Project Name: Raymond's Polymer Storage

# REVIEW COMMENTS

FILE #SPR-96-162

C15 SITE PLAN / GRADING & DRAINAGE PLAN / LANDSCAPE PLAN  
1/8" = 1' = 0"

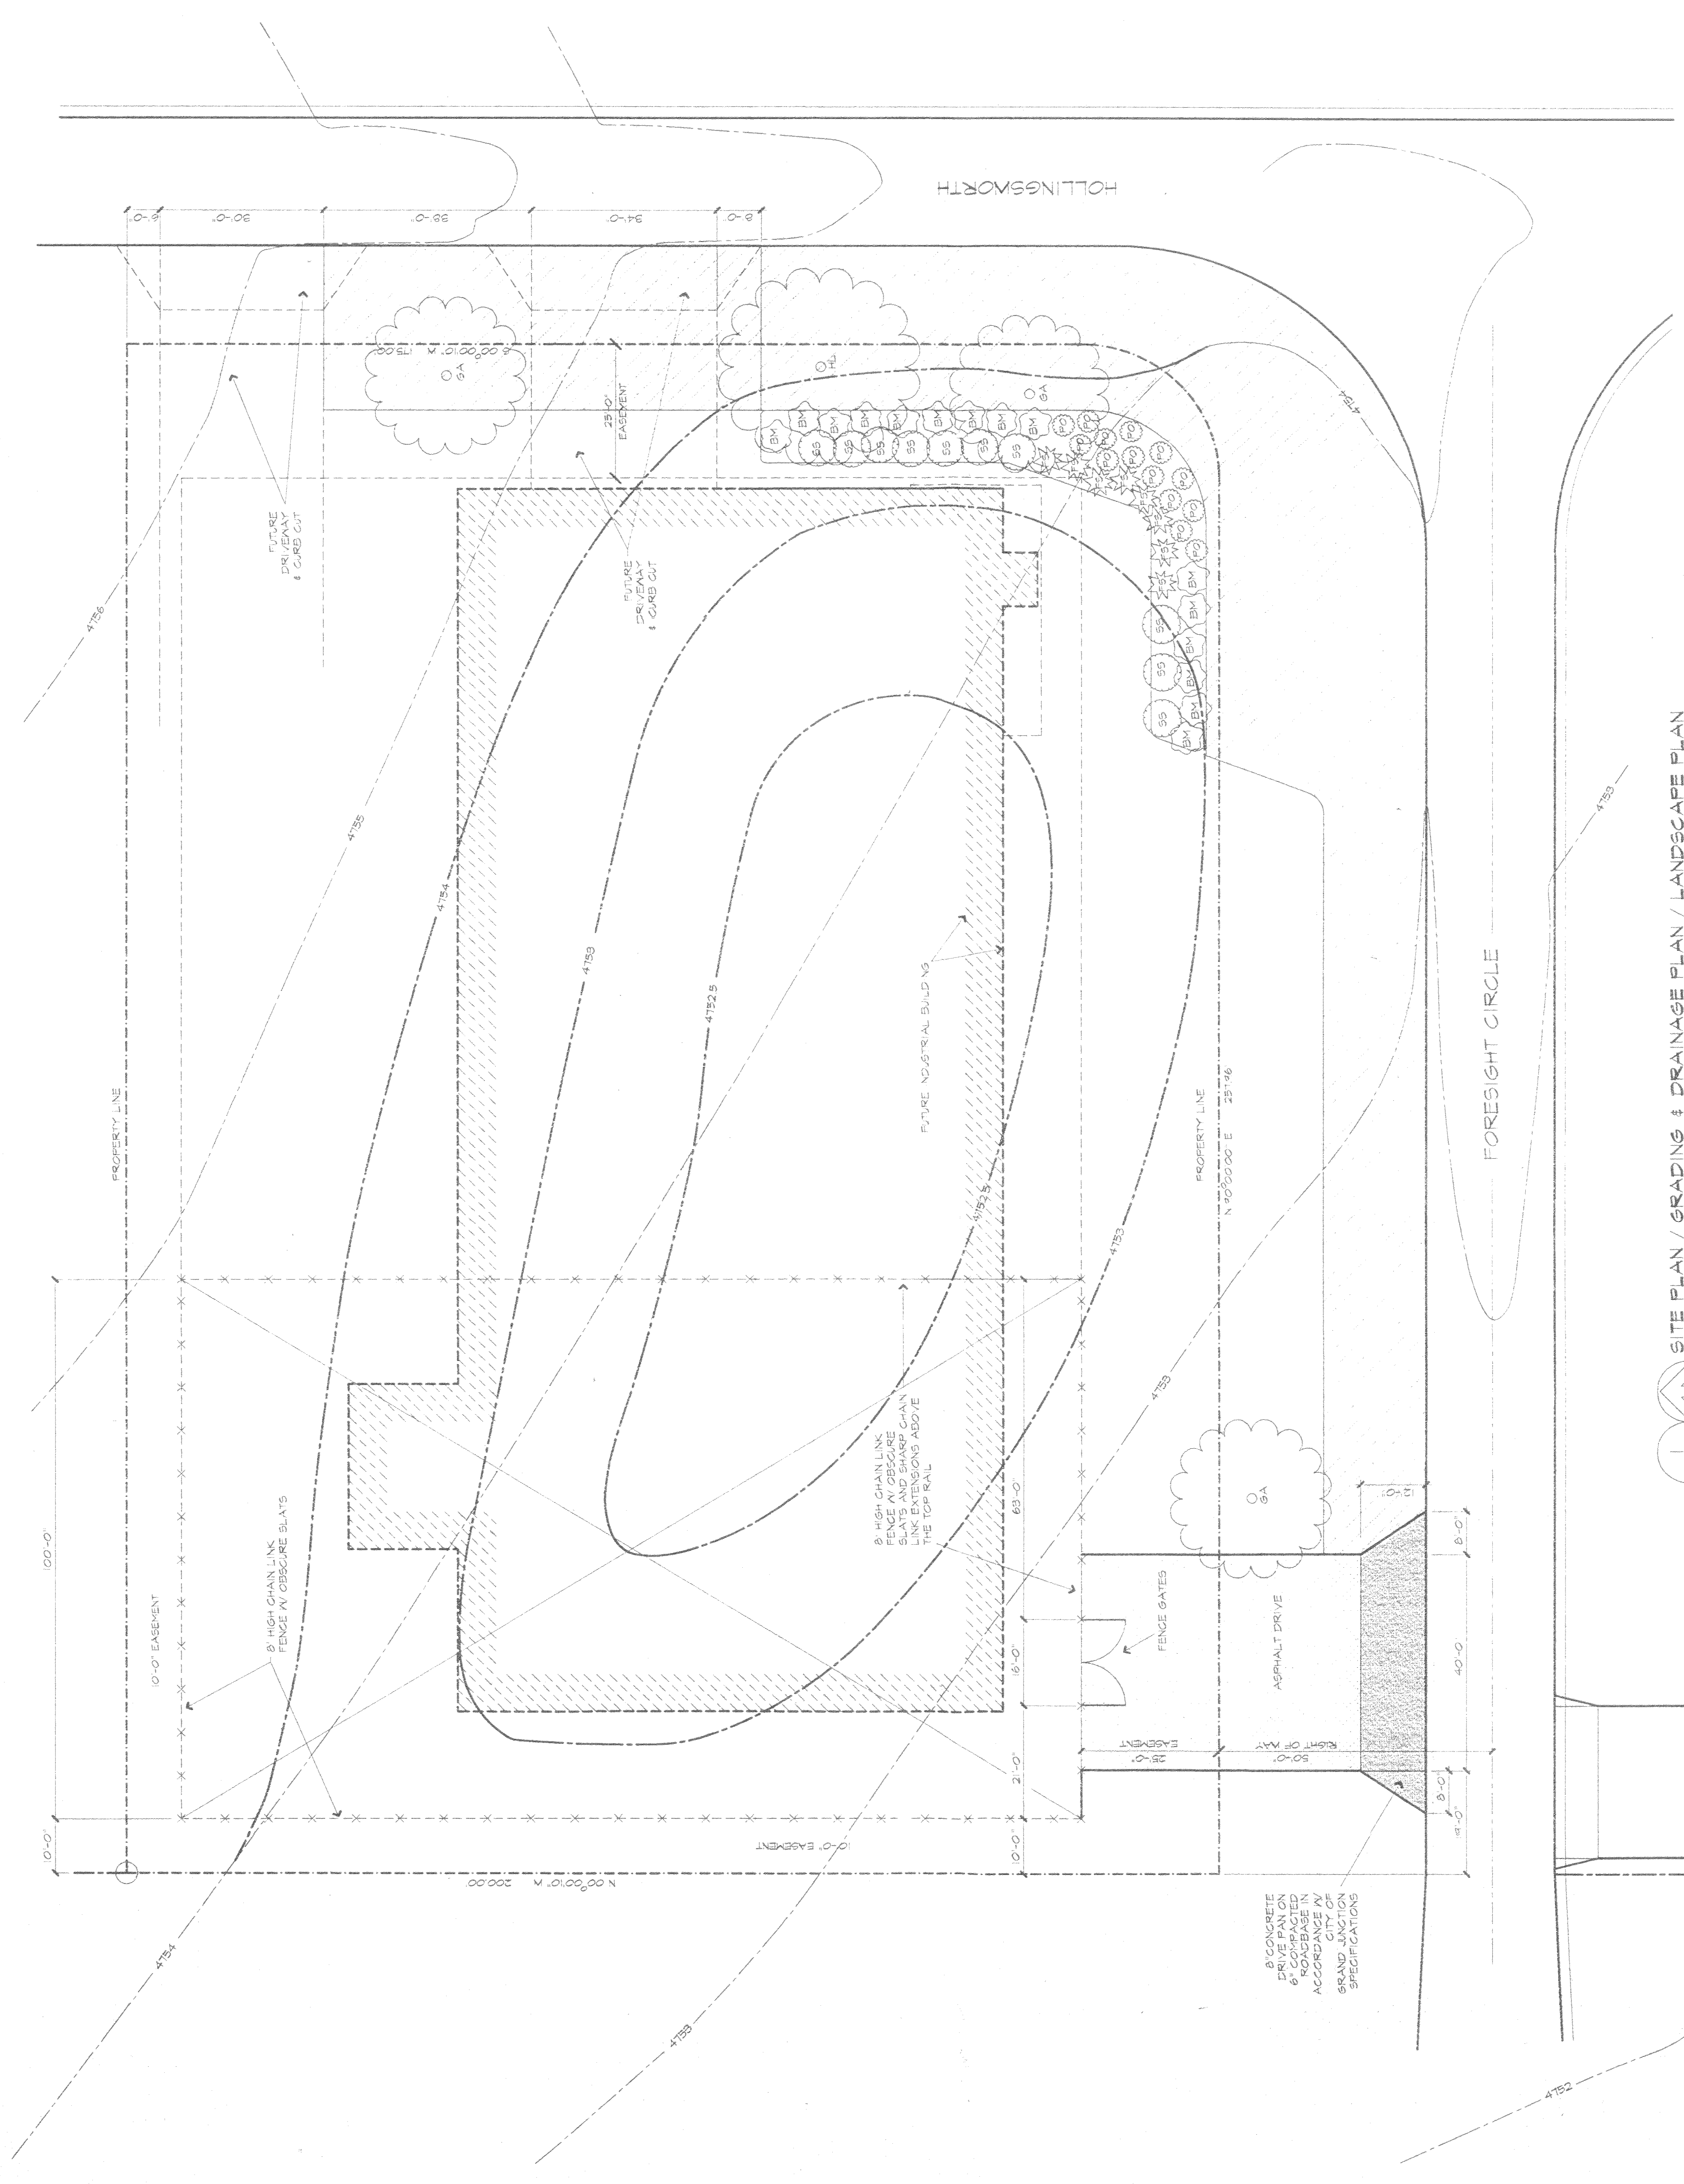
1. Landscaping for Phase 1 (storage area) must include minimum landscaping for typical light industrial zone. Based on the calculation of total landscape area, this would require placement of a minimum of 4 trees and shrub coverage of a minimum of 640 square feet.

Plan will then need to include a table indicating number, species and planting size of all plants.

2. Is there any security lighting proposed?
3. Correct spelling of "industrial" on note indicating footprint of future building.

1. The driveway shown on Foresight Circle exceeds the maximum width for a commercial driveway. City standard width is 20-40'. The location is closer to the property line than is typically allowed. Is there a nearby driveway with the adjacent property which will conflict?
2. You may want to consider holding off on constructing the other driveways until site plan approval for the building to be sure circulation and parking will work. What is the purpose for the driveway to the front of the building?
3. A permit from the City Engineer's office is required prior to construction of any curb cuts.

1. The use of obscuring chain link is not bad as long as the fence is at least 8' high. Ideally, a run of 3 strand barbed wire should also be used on top of the chain link.
2. If the barbed wire idea is unacceptable, then make sure the fencing company leaves the pointed spiked ends of the chain link exposed on the top portion of the fence. If the City decides that the 8' fence is too high, then the obscuring slats should be removed and interior lighting increased to provide better surveillance for passing police patrols.

1. The drawing shows an access road from the street that is 40 feet wide. The committee, in accordance with the covenants, requires that this access road have a maximum width of 26 feet.
2. It is the committees understanding that the fence proposed on the plan is temporary and will be taken down and replaced by a building. Since the fence is temporary, the fence is approved for a time period not to exceed one year. The committee believes it would not be in the best interest of the park to allow the fence to stand indefinitely.

1. Landscaping. Reference revised drawing, Sheet C1.5.
2. No security lighting is proposed.
3. Spelling of "Industrial" has been corrected on Sheet C1.5.

1. The driveway on Foresight Circle has been reduced in width to 40'-0" and is shown on revised drawing C1.5 as 19'0" from the west property line.
2. The two curb cuts and driveways on Hollingsworth are shown on revised drawing C1.5 as future curb cuts and driveways.
3. A permit shall be obtained from the City Engineer's Office for the proposed curb cut prior to commencement of construction.

1. The chain link fence is shown to be 8'-0" high.
2. Spiked ends of the chain link fencing are specified to extend above the top rail. Barbed wire will not be used.

At your request, the Foresight Park Architectural Control Committee has revisited this covenant with respect to your plans and the Committee has agreed to allow you an access road from the street that is 40 feet wide as proposed in the site, grading, drainage, and landscape plan for Reynolds Polymer Technology, Inc. dated July 23, 1996 and labeled as drawing number C1.5.
